Western Digital Corporation
 5863 Rue Ferrari
 San Jose, CA, 95138

To: T10 SAS Protocol Working Group
 Contact: Mark Evans
 Phone: 408.363.5257
 Email: mark.evans@wdc.com
 Date: 28 April 2008

Subject: SAS-2+, low power transceiver options, phy and link states

Figure a — PM (phy layer) state machine - SAS low power transceiver recovery states

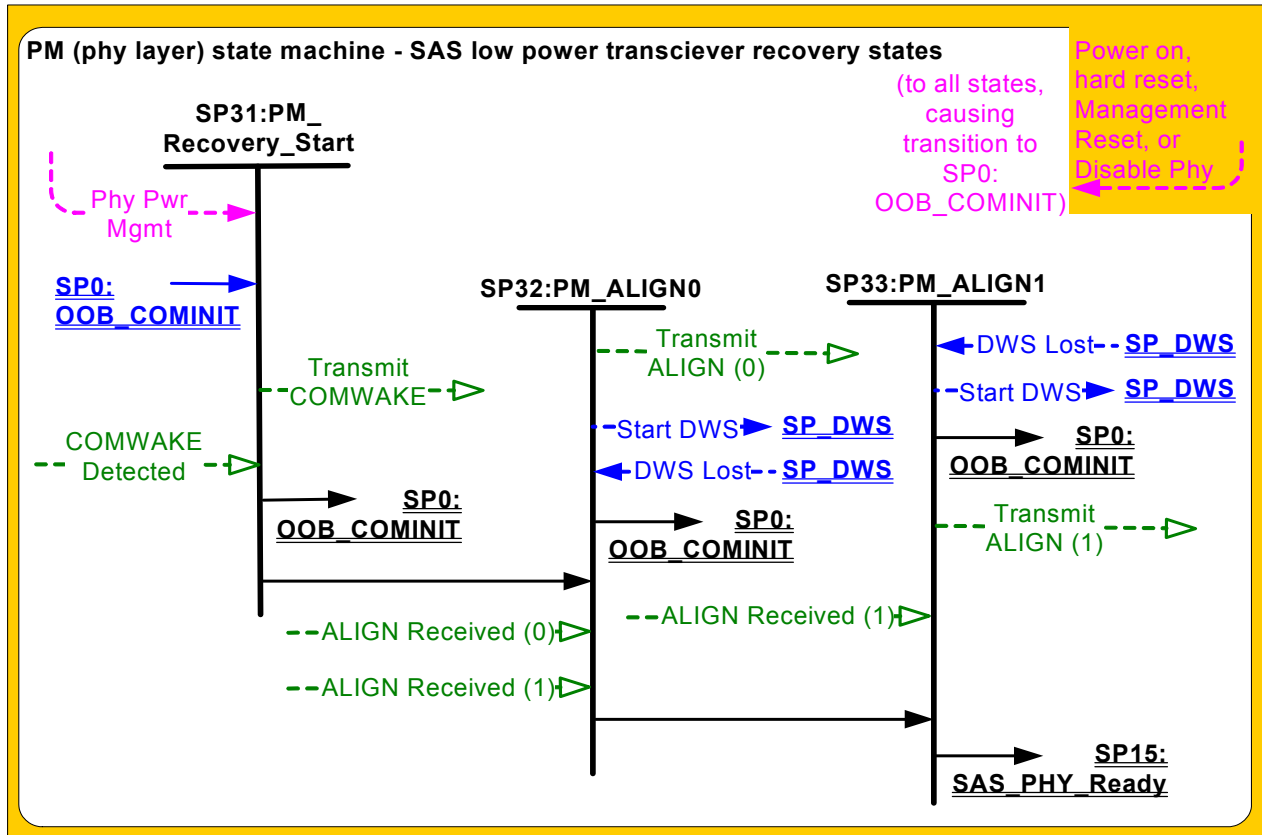
[Editor's note: this is a new clause with a new figure.]

Figure a shows the SAS phy low power transceiver recovery states. These states process the actions that return a phy from a low power state to participating in an operational logical link. These states are indicated by state names with a prefix of PM.

Figure 184 — SL (link layer for SAS logical phys) state machines (part 2) [\[replacement\]](#)

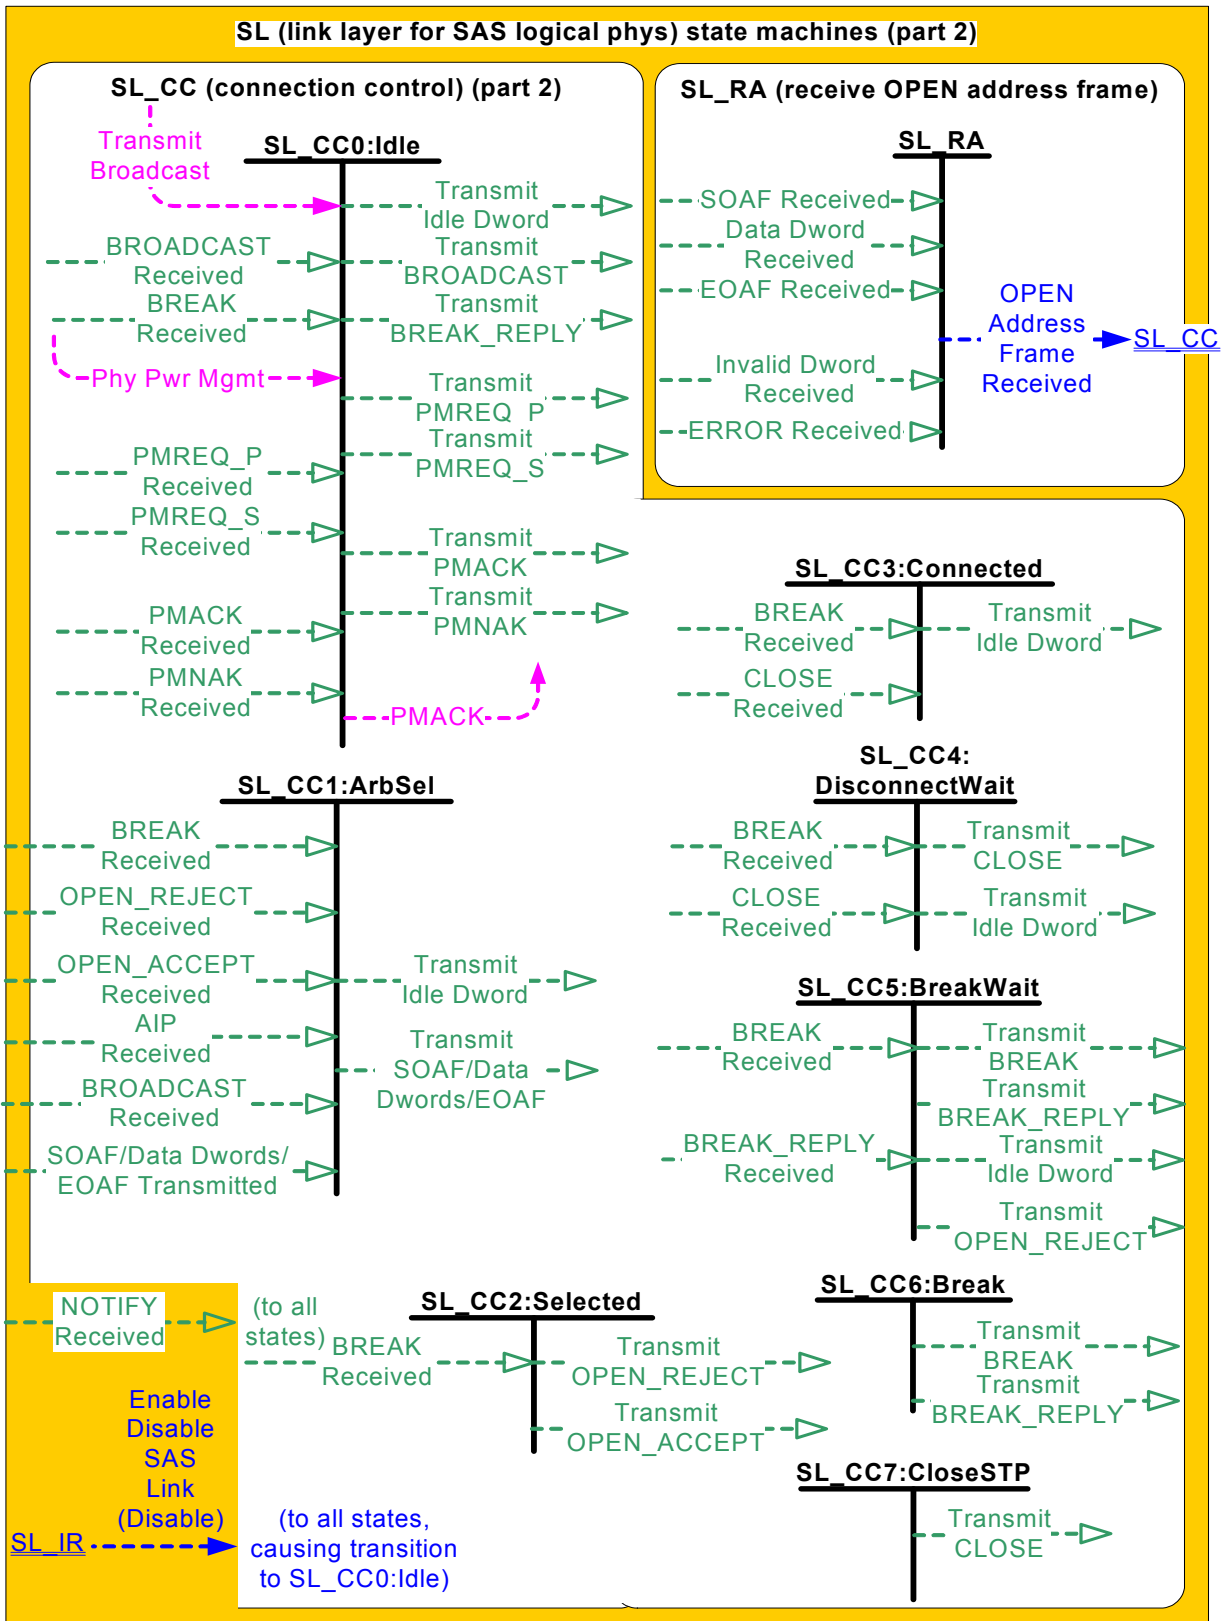
2) The following are the proposed changes to the SL state machine.
